# CITY OF ALBUQUERQUE

RE: **Coors Blvd Wecks**  
**730 Coors Blvd NW**  
**Revised Grading and Drainage Plan**  
**Engineer's Stamp Date: 5/21/19**  
**Hydrology File: J11D032**

Based on the submittal received on 5/21/19, the revised Grading and Drainage Plan is re-approved for Site Plan for Building Permit (Administrative Amendment) and Building Permit.

C-201

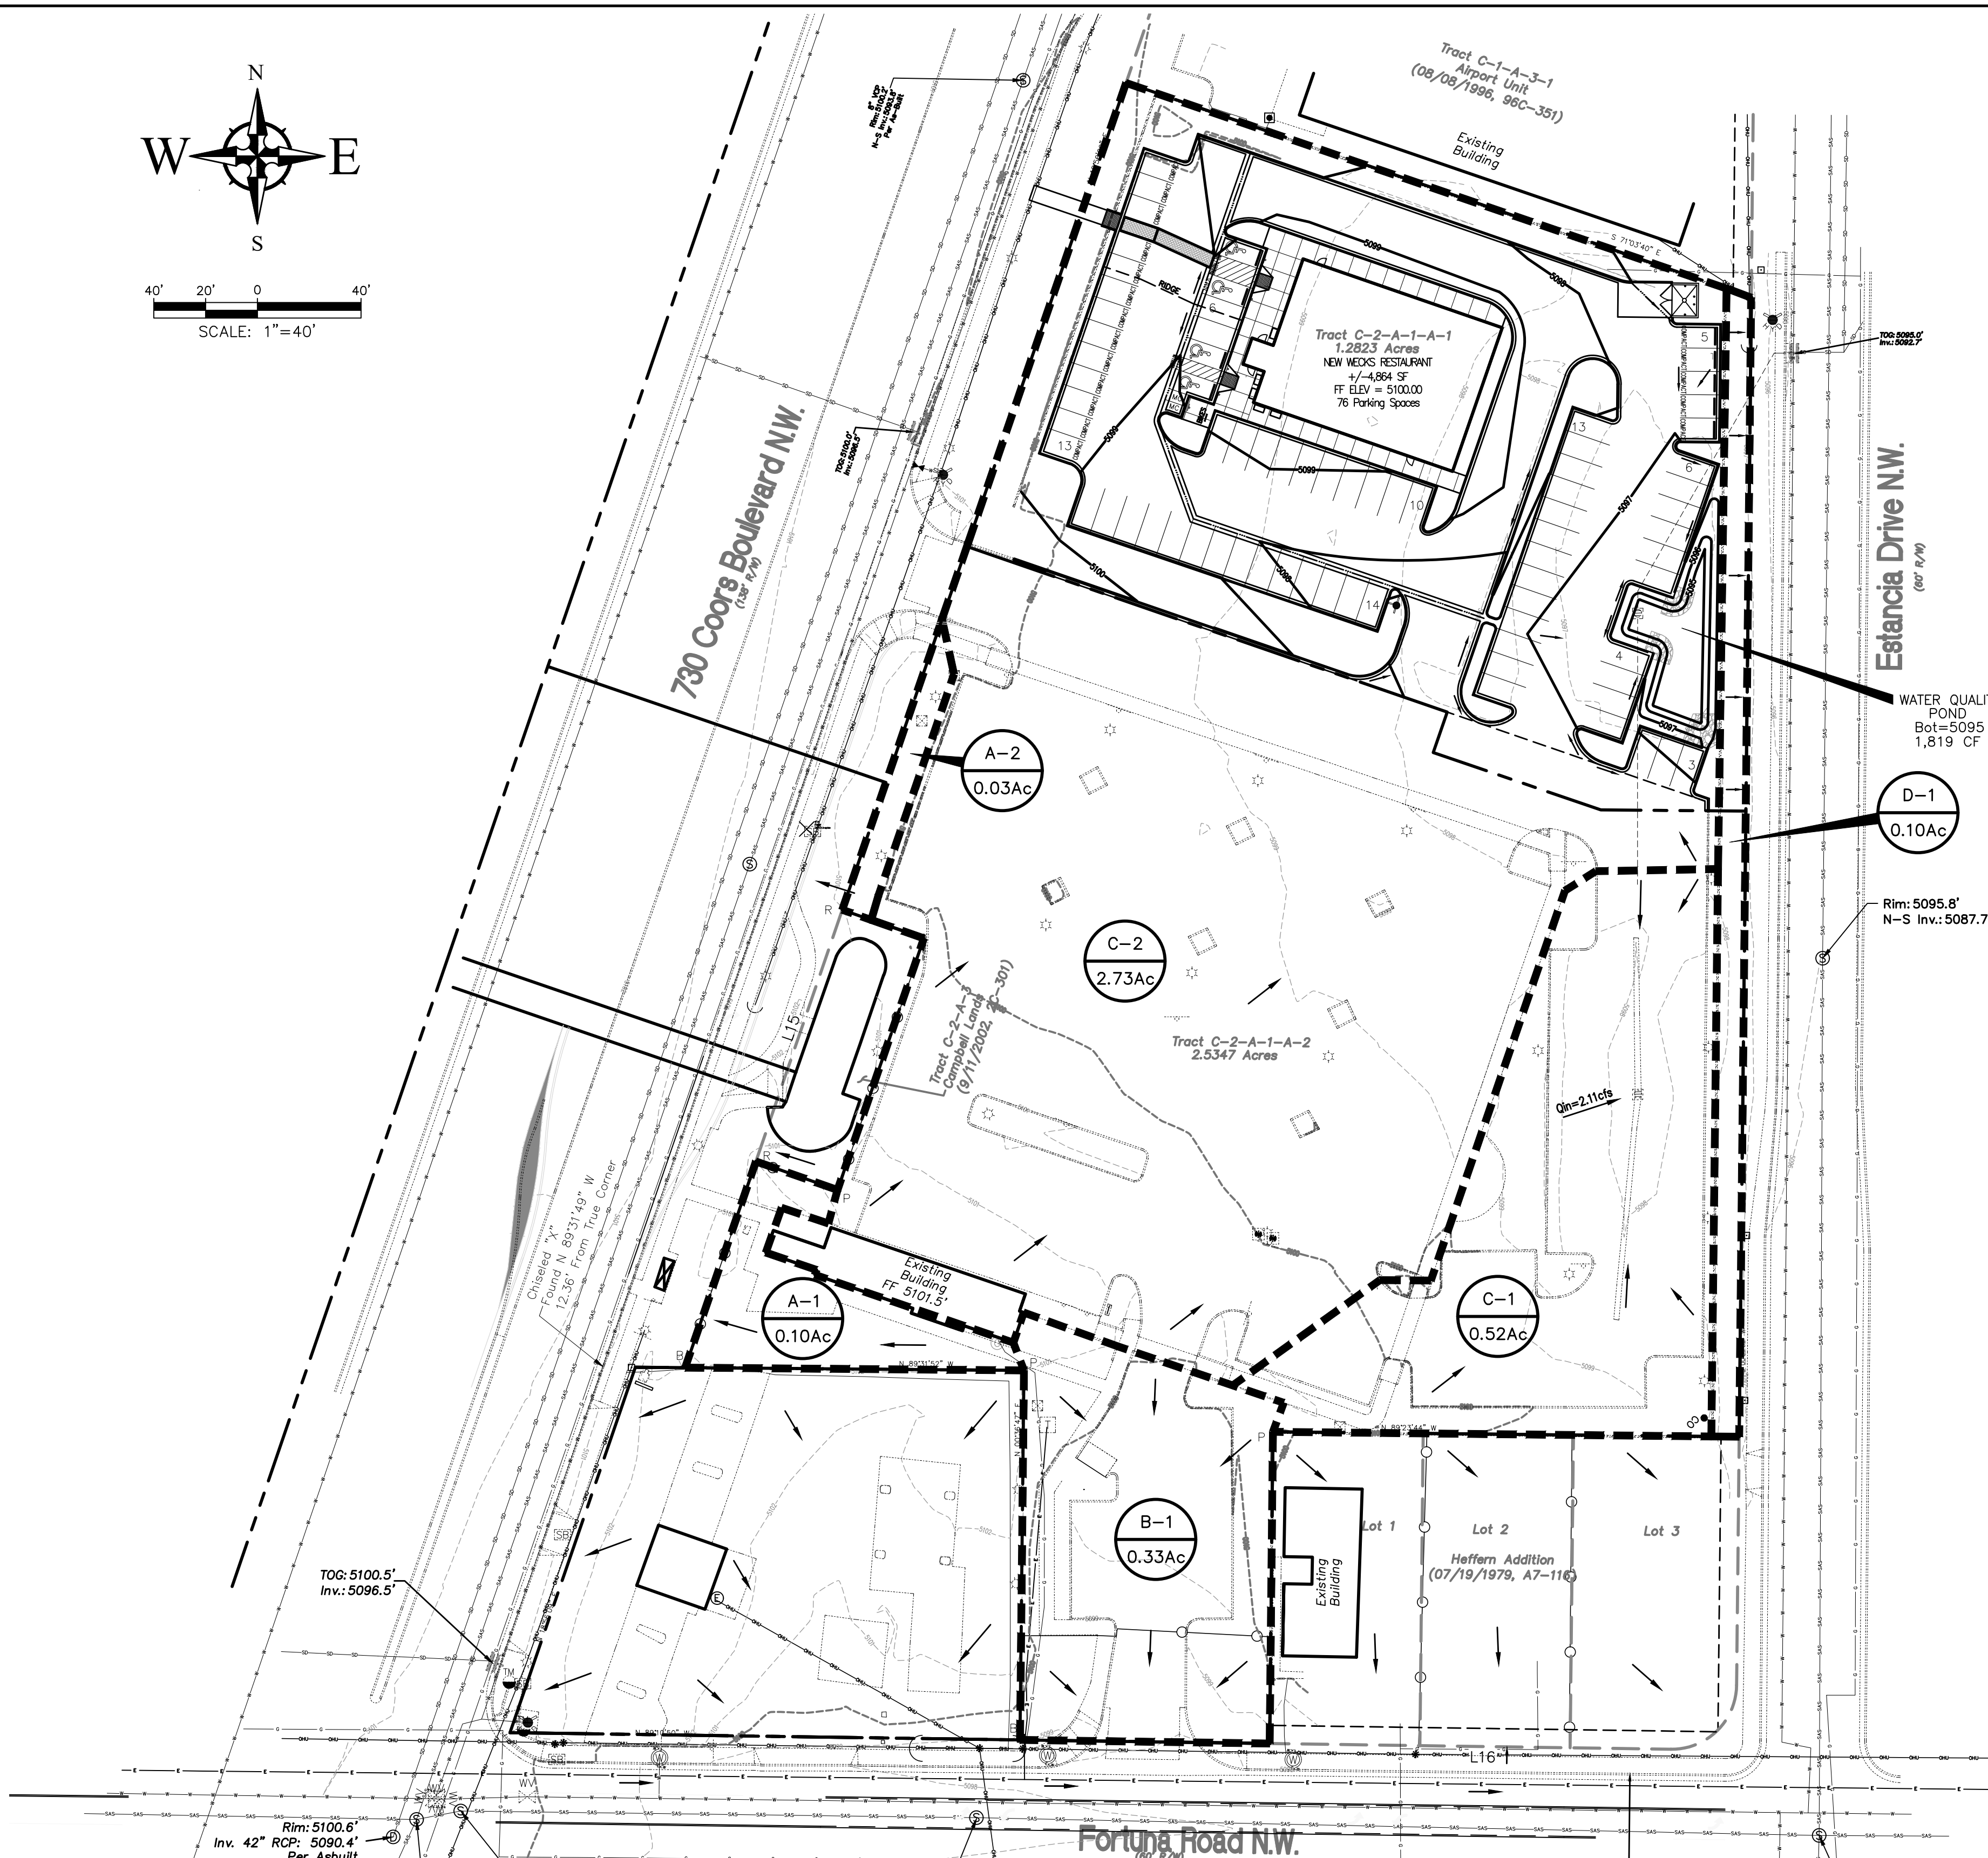
1. Engineer's Certification, per the DPM Chapter 22.7: *Engineer's Certification Checklist For Non-Subdivision* is required.
2. A Bernalillo County Recorded [Private Facility Drainage Covenant](#) is required for the stormwater quality pond. The original notarized form, exhibit A (legible on 8.5x11 paper), and recording fee (\$25, payable to Bernalillo County) must be turned into DRC (4th, Plaza del Sol) for routing. Please contact Charlotte LaBadie (clabadie@cabq.gov, 924-3996) or Madeline Carruthers (mtafoya@cabq.gov, 924-3997) regarding the routing and recording process for covenants. The routing and recording process for covenants can take a month or longer; Hydrology recommends beginning this process as soon as possible as to not delay approval for certificate of occupancy.
